2024/0005/DET

Representations - objection

RE: Planning **objection** to [2024/0005/DET | Erection of 6no. houses \(3 blocks of semidetached\) | Land 65M South Of 22 Kerrow Drive Kingussie \(eplanningcnpa.co.uk\)](#) (Relevant also to: [2020/0013/DET | Erection of 22 apartments, formation of access road, SUDS, landscaping | Land 65M South Of 22 Kerrow Drive Kingussie \(eplanningcnpa.co.uk\)](#))

Figure 2: Strava heatmap of site

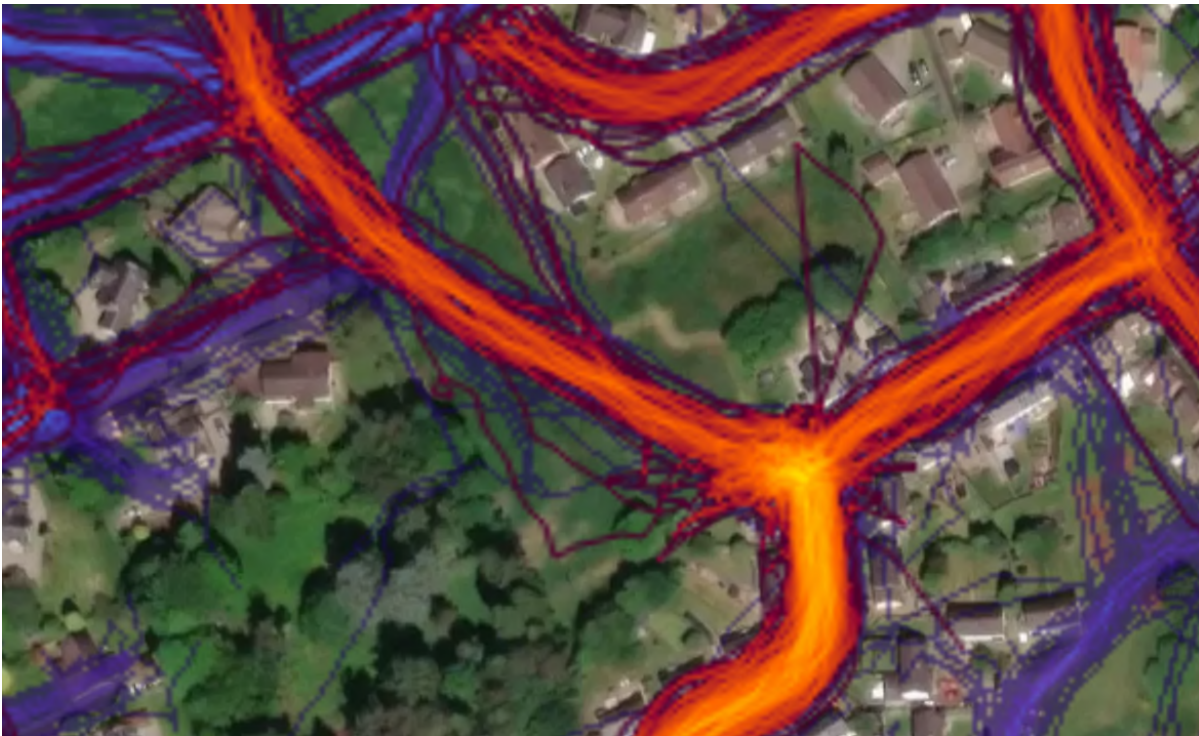
There is existing housing on all sides of the site which, while not currently densely packed, would become so following new housing construction on the site. The site itself is currently heavily used recreationally, along with Tom Baraidh to the north, as indicated by the Strava heatmapping below.
